Project Title:	Priors Farm, South Wokingham SDL
Project No/ Document Reference:	A218 – R062
Date:	18 May 2026
Author:	TDM

FC Highways : Matters & Clarifications

Drawing No. A218-069/P2
Old Wokingham Rd / Easthampstead Rd Junction Improvement

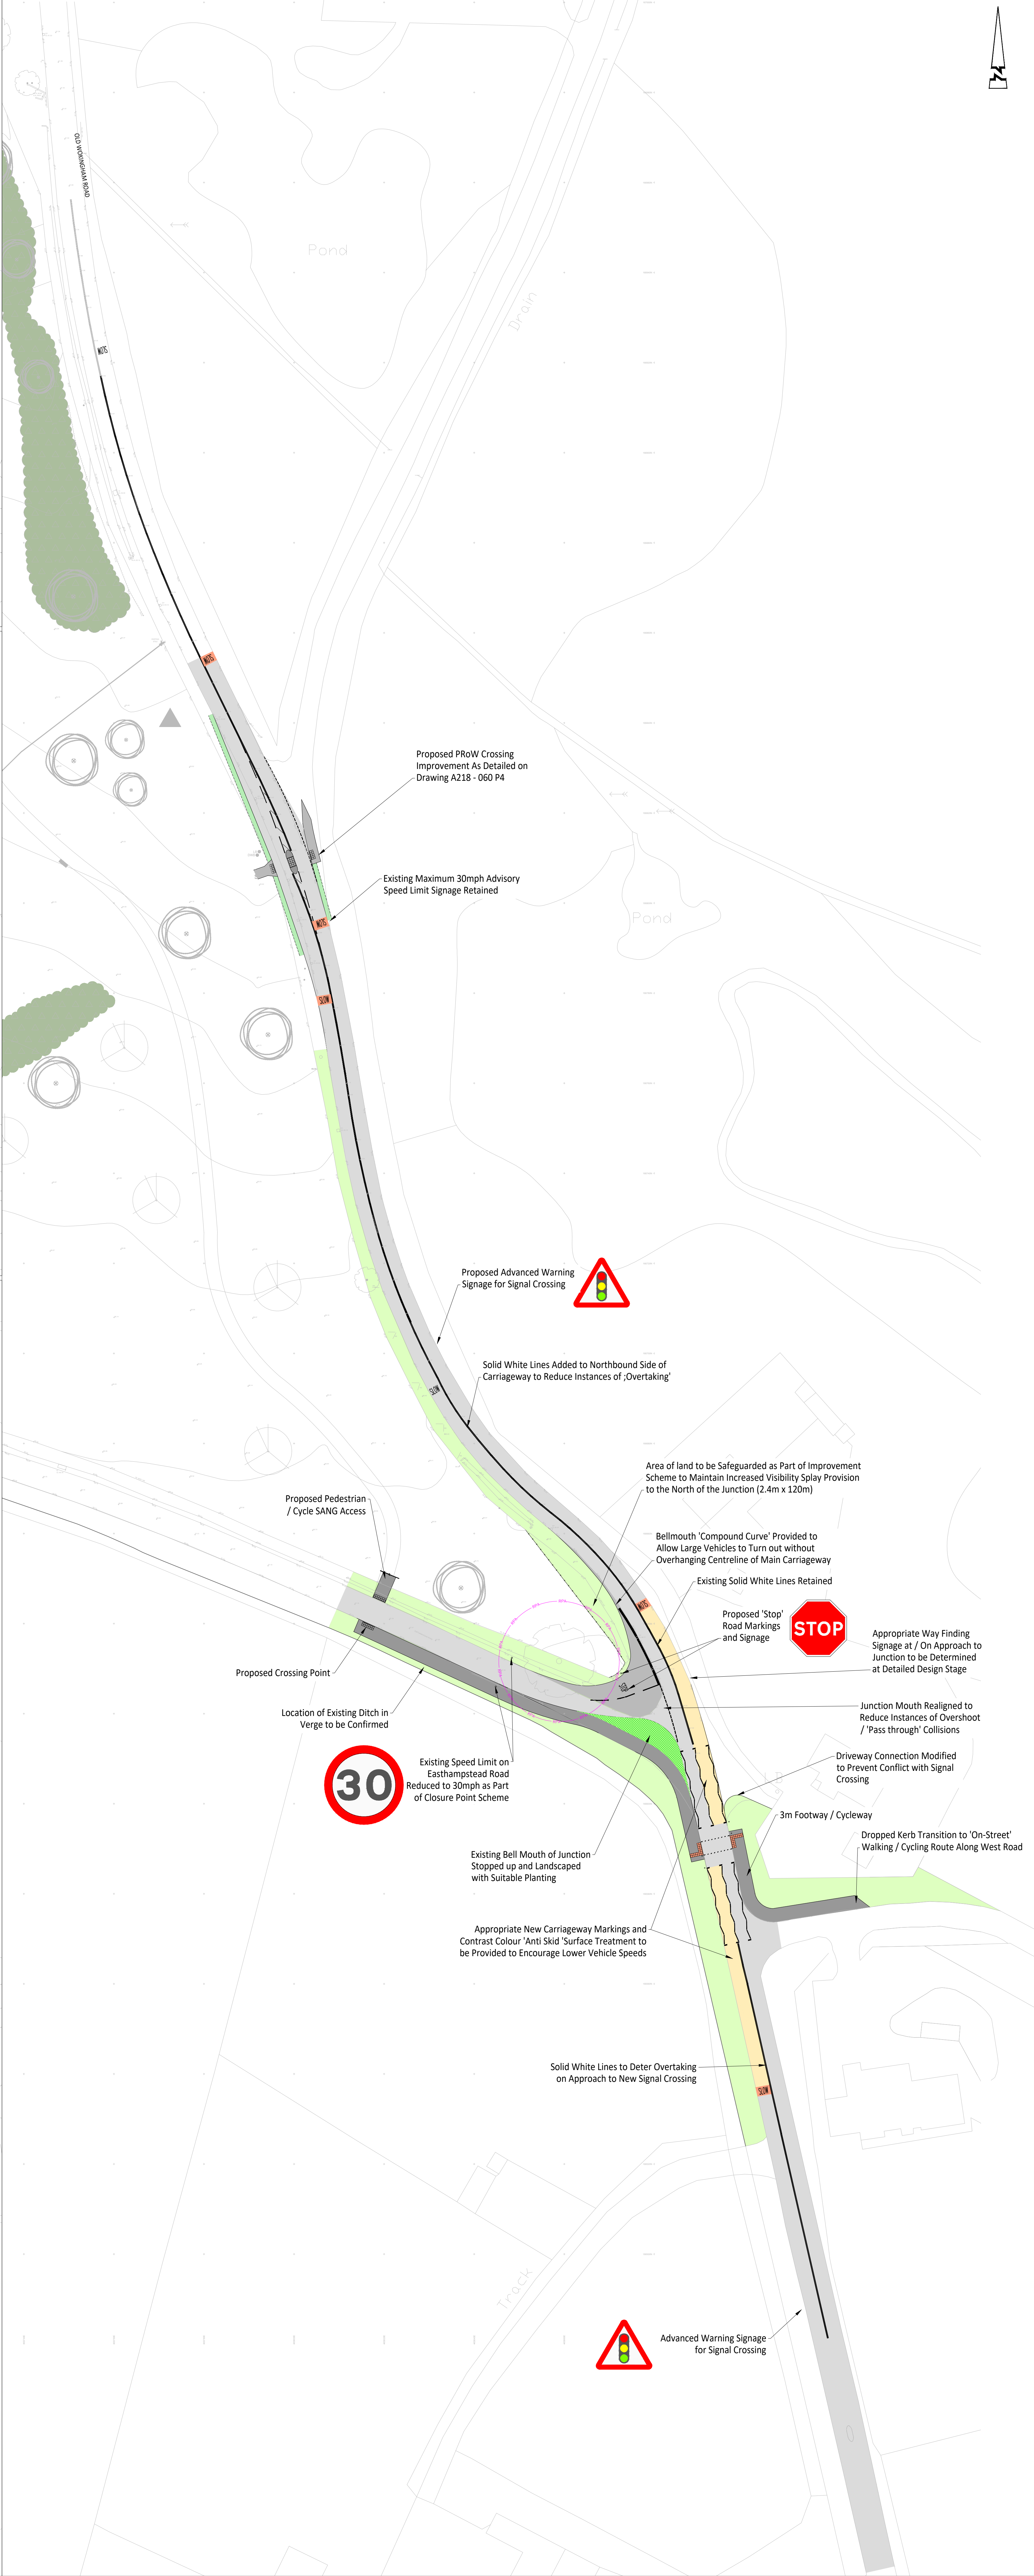
Comments on Drawing A218-057 revision P3. The proposed crossing is in a 40mph speed limit area, which is unlikely to be acceptable for an isolated crossing. No details of the visibility from the crossing have been provided, and visibility from the western side of the crossing to the north is likely to be insufficient, with a resulting impact on highway safety.

The proposed footway stub on Easthampstead Road does not appear to link to a defined pedestrian route into the parcel nor a defined pedestrian route along West Road

No provision for cyclists has been set out

Details of street lighting will need to be provided for a new crossing of this type. There may be insufficient highway margin to position them

Solid white line markings have been proposed, but this is highway which is in BFC control and would require a Section 278 agreement

No assessment of the safety of the Easthampstead Road junction has been provided. With additional through traffic on Old Wokingham Road from the development it is likely that vehicles would try to exit in too small gaps causing collisions, which are already a regular occurrence at this junction. A comprehensive junction redesign is required, incorporating pedestrian provision as part of the junction design, not a standalone crossing

With regard to STOP signs and markings, Traffic Signs Manual Chapter 3 sets out that new STOP sign locations should not be created:

“2.1.3. It is expected that most junctions that satisfy the criteria for STOP signs already have signs in place. New junctions should not be constructed with very poor visibility, so the provision of new STOP signs should be exceptional. Consultation with the police for their support on enforcement is recommended.

2.2.1. STOP signs, other than at junctions with tramways, should be provided only where visibility is so restricted that it is essential for drivers to stop before entering the major road (see 2.5 for railway and tram crossings). The sign will be well respected only if drivers can see the need for it. The possibility of making a visibility improvement at a junction should always be investigated before considering a STOP sign.”

- 4.1. Regarding the proposed crossing improvement illustrated on Drawing No. A218-057/P3 and the comments from BFC provided above, we would note that Design guidance available in the UK does not generally specify an upper speed limit for the provision of a crossing on public highway, subject to the provision of appropriate Stopping Sight Distances and advanced warning signage.

- 4.2. It is acknowledged that the Annex to CD143 – Designing for Walking, Cycling and Horse-riding (guidance for crossings adjacent to the Motorway or all-purpose trunk road network) states in para E4.5 that “*stand alone controlled crossings for pedestrians and cyclists shall not be provided where the 85th speed exceeds 50mph*”. However, the guidance also states in para E4.3 that “*For the assessment of pedestrian crossings LTN 1/95 and 2/95 shall be used*”.

- 4.3. LTN 2/95 states: “*2.9.1 Where a signal-controlled crossing is sited on a road where the speed limit or 85 percentile speed on any approach is 50mph or greater, advance warning signs to diagram 543, Traffic Signs Regulations and General Directions 1994 should always be used*” (now Diagram 543 Under Traffic Signs Manual Chapter 6). Traffic Sign Manual Chapter 6 also indicates that where 85th speeds are between 36 – 40mph the above advance warning sign should only be installed if forward visibility is less than 100m.

- 4.4. Given that the posted speed limit is 40mph and that the proposed crossing is not an isolated feature but a part of several highway improvements and alterations being delivered along the Old Wokingham Road corridor as part of the Priors Farm development, the provision of the signalised crossing is considered to be entirely appropriate.

- 4.5. Drawing No. A218-057/P3 clearly shows Stopping Sight Distances of 120m both northbound and southbound to the proposed signals heads (in the bottom right viewport), as is required for a signalised crossing.

- 4.6. West Road is a quiet private road which understandably currently operates in the form of a ‘shared surface’. Similarly, Easthampstead Road in turn will benefit from the point closure accompanying the Priors Farm development proposals, becoming a quiet rural lane serving Active Travel and modest access demand to a new SANG car park and existing occupiers. The design clearly indicates provision for cyclists and pedestrians with 3m shared footway / cycleways leading from West Road and Easthampstead Road up to the crossing point on Old Wokingham Road which is entirely appropriate for the expected level of use the facility will experience.

- 4.7. Details relating to lighting design and the provision of road markings are matters that can be addressed through the subsequent S278 Technical Approval process in the normal manner. Notwithstanding, at this stage it is evident that there is sufficient highway land along the eastern edge of Old Wokingham Road for the provision of street lighting.

- 4.8. Further to the standard assessment of highway safety through review of collision data undertaken in the originally submitted Transport Assessment, which at the time indicated a single collision within the five-year period, an additional assessment of the safety at the Easthampstead Road / Old Wokingham Road junction has been undertaken in Abley Letchford Technical Note Ref : A218-R058 using the DfT ‘COBALT’ methodology.

- 4.9. This demonstrates that the proposed development and associated Easthampstead Road point closure would result in a significant reduction (approximately 45%) in predicted Personal Injury Accidents by the 2040 design year. The assessment confirms that the proposals would materially improve, rather than worsen, highway safety at this location.
- 4.10. Since the receipt of these comments, ongoing engagement with BFC has resulted in further refinement of the proposed design, as set out on Drawing A218-069/P2 (**Appendix C**). These works will be provided to complement the highway safety benefits which will accrue from the point closure along Easthampstead Road.
- 4.11. BFC have provided further comments relating to the proposed Easthampstead Road / Old Wokingham Road improvement scheme via email on Wednesday 6th May 2026 stating:

- 4.12. The proposed layout provides full 2.4 m x 120 m visibility splays. On this basis, STOP markings are not strictly required under the guidance. However, whilst reference is made to TSM Chapter 3, much of this guidance relates to new junctions, with visibility standards based on 85th-percentile speeds. For existing junctions, the need for STOP control (TSM3 paragraph 2.2.2) is influenced by a wider range of factors, including traffic volumes, minor-arm gradient, collision history, alignment, and other site-specific difficulties.

- 4.13. Highway safety and mainline AADT were central to BFC’s request for additional measures (alongside the proposed closure of Easthampstead Road to through traffic). In particular, BFC highlighted pass-through collisions where drivers fail to stop and have collided into the wall opposite. The incorporation of a Stop sign is therefore considered a worthy component of the robust package of measures to mitigate accident risks at this location. Should however BFC consider that a ‘give way’ arrangement is sufficient in the context of the significant reduction traffic utilising Easthampstead Road; the accident analysis results; and the other safety features being proposed at the junction, then this minor amendment can be made as the scheme progresses through the subsequent s278 Technical Approval process in the normal manner.

- 7.3. Similarly, for the reasons set out in this Technical Note, **Drawing No. A218-069/P2** demonstrates that BFC's comments relating to design speed, visibility splays, swept paths, cycle provision, road signs and verge widths have been accommodated within the design of the Easthampstead Road / Old Wokingham Road junction improvement and signal crossing scheme.
